No.	REVISION	BY	DATE	H-SCALE 1"=300'	V-SCALE N/A	DATE 1/23/23	DESIGNED BY DJV	DRAWN BY WUL	CHECKED BY	SAND CREEK RESTORATION	GEC PLANS	SHEET 90 OF 111	JOB NO. 25188.04

SAND CREEK RESTORATION

GEC INITIAL

SHEET 91 OF 111

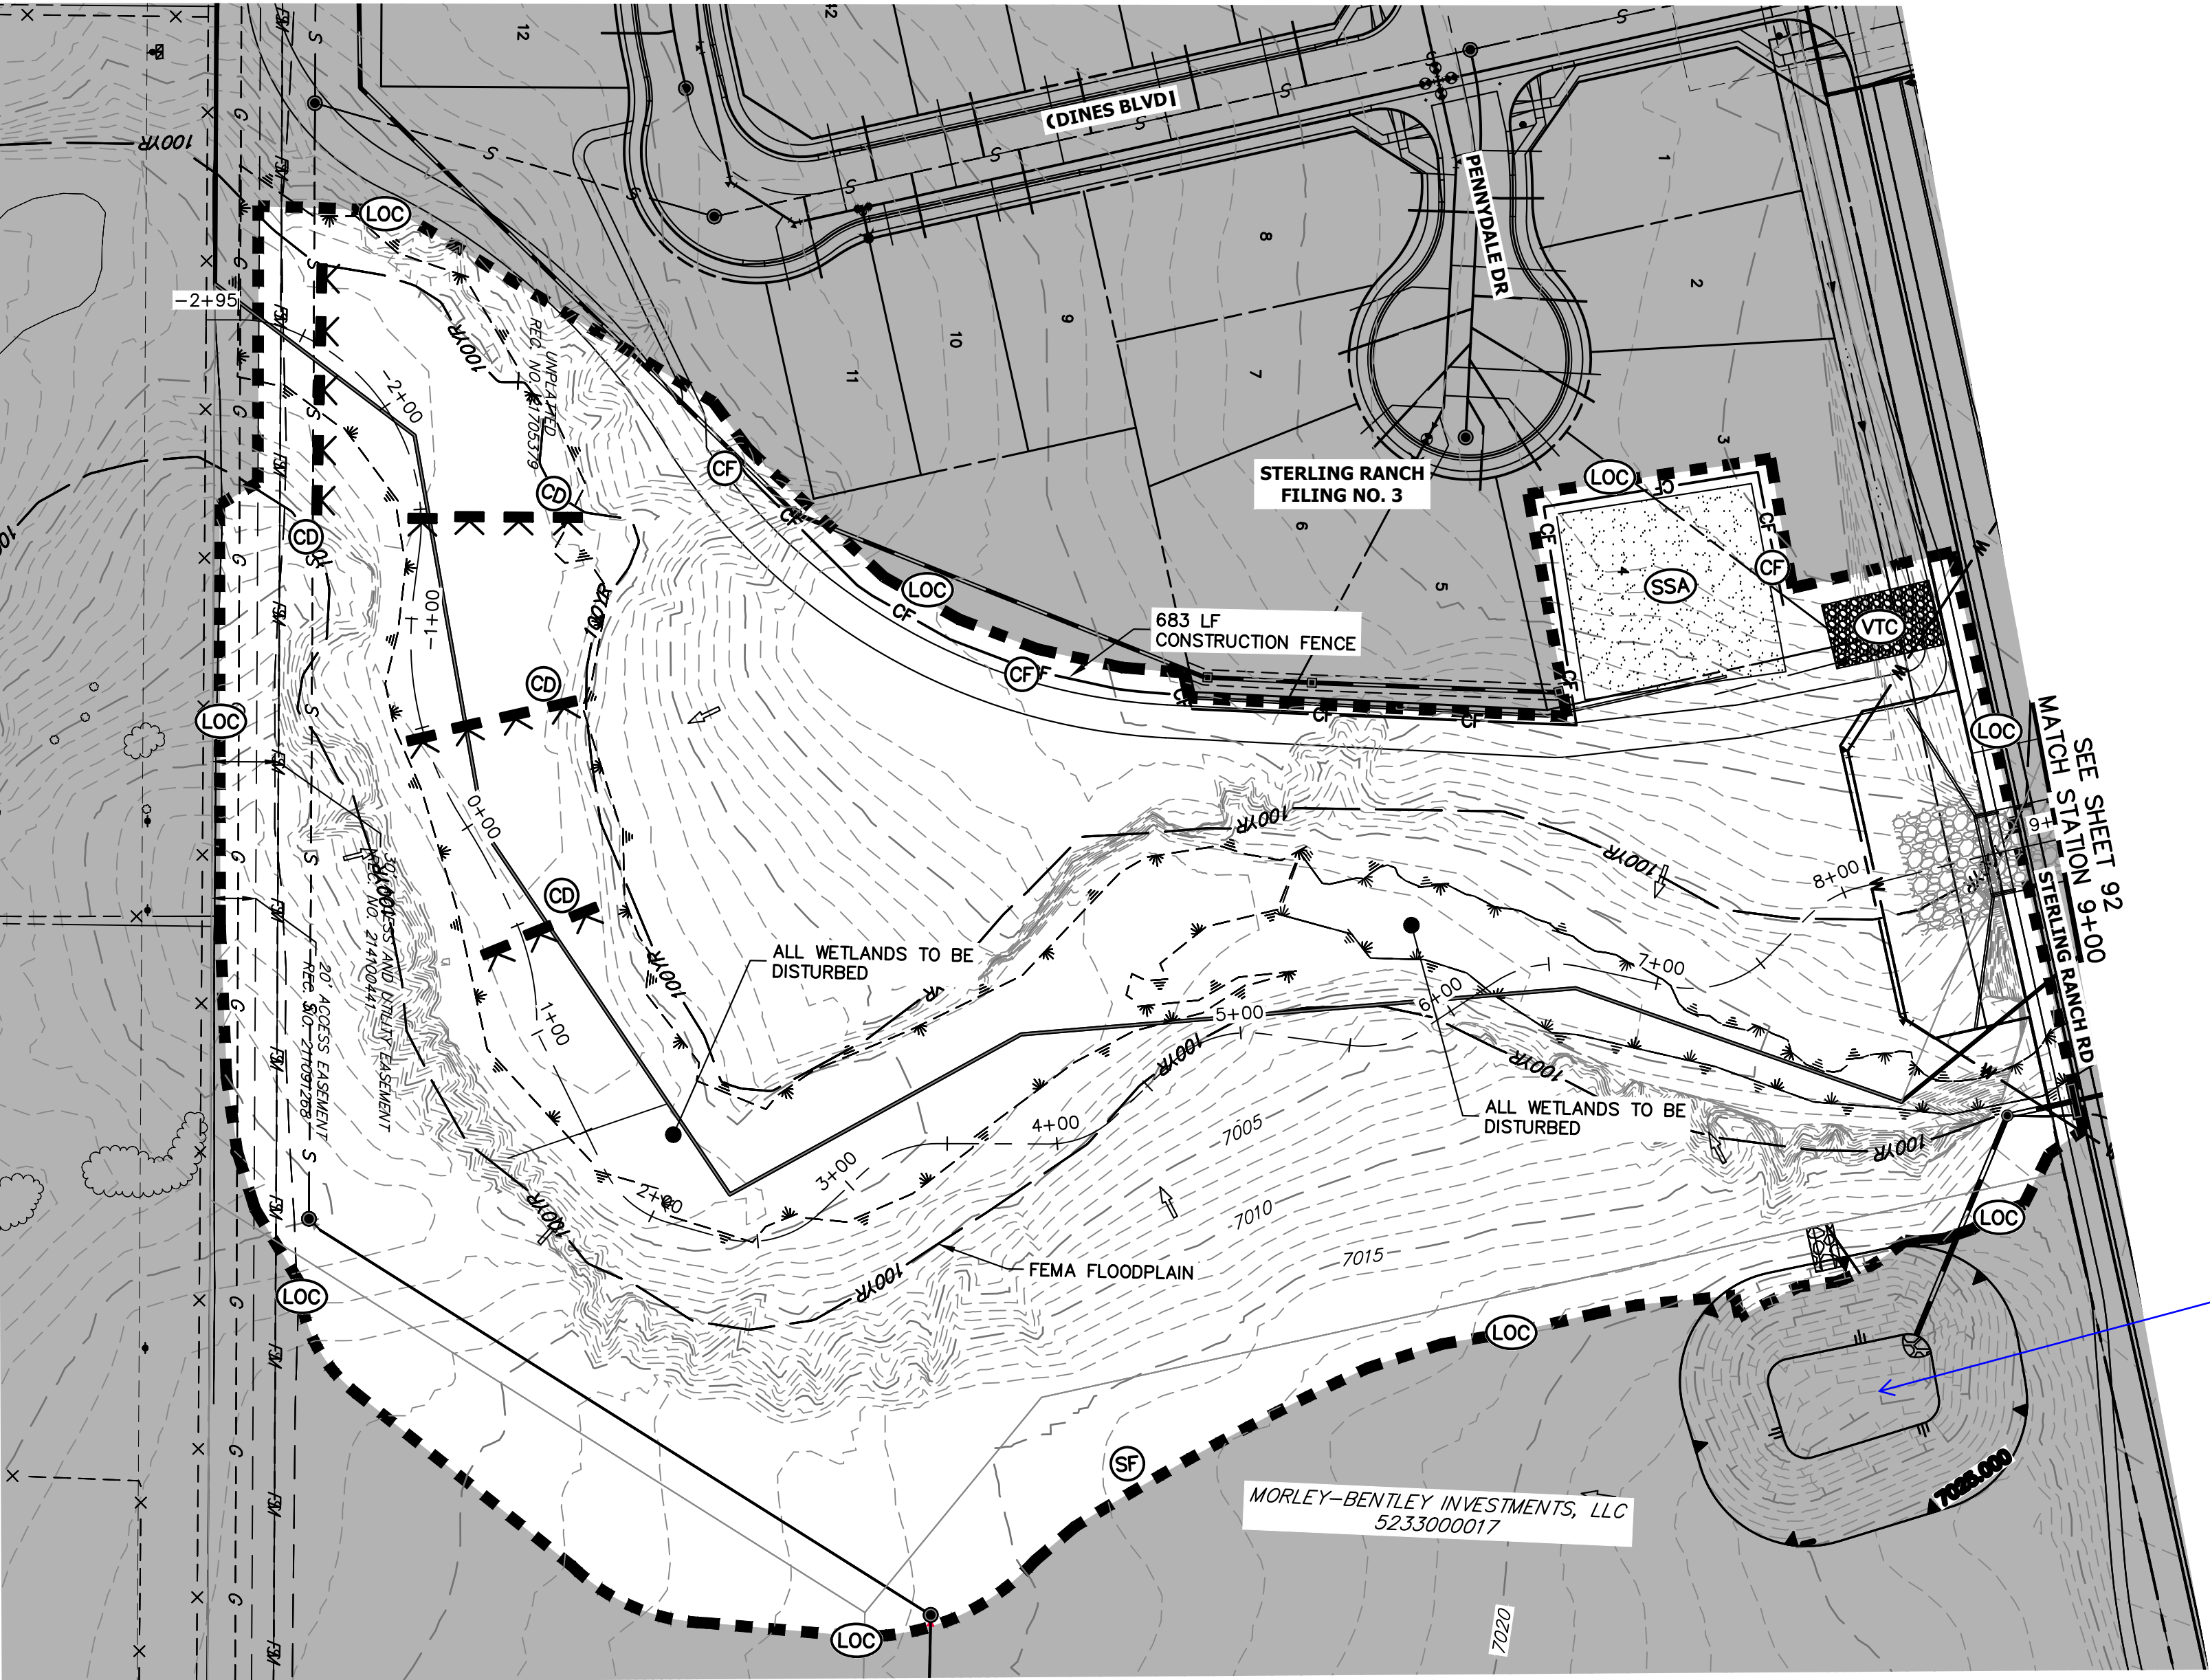
Label  
(delete?)

SHEET 99 OF 111  
JOB NO. 25188.04

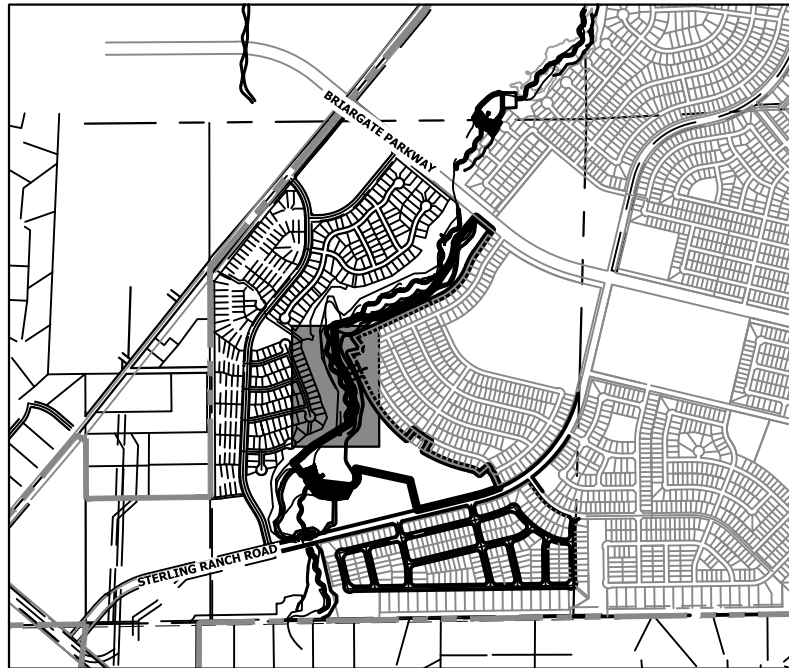
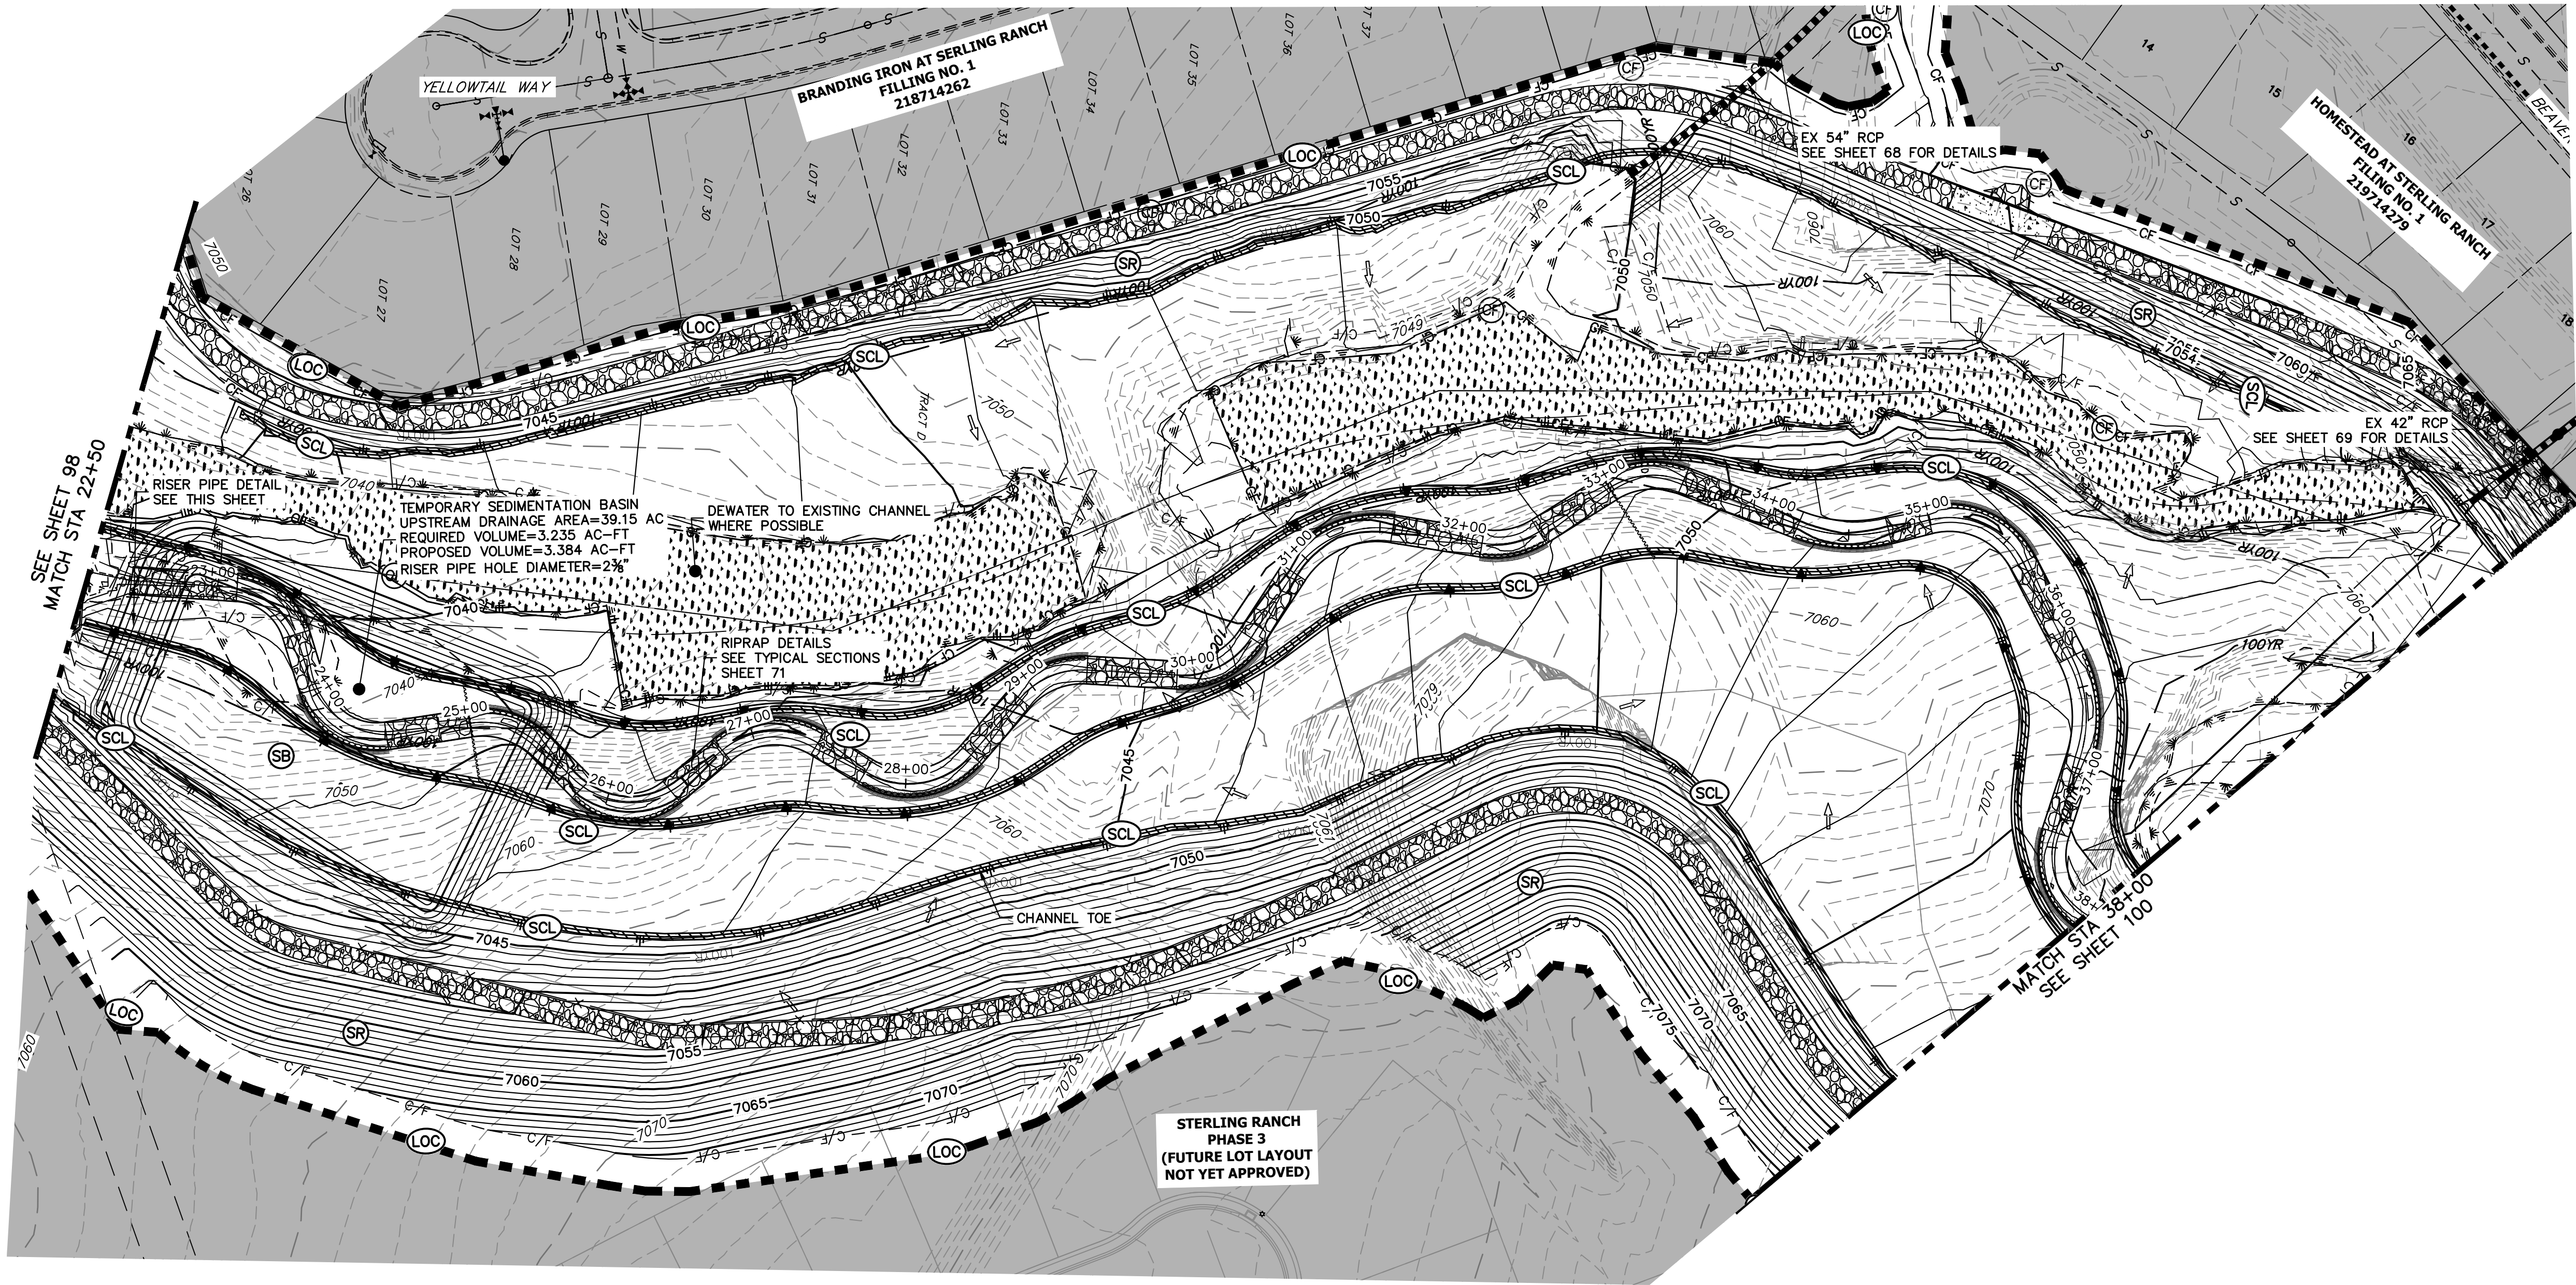
Expand viewport
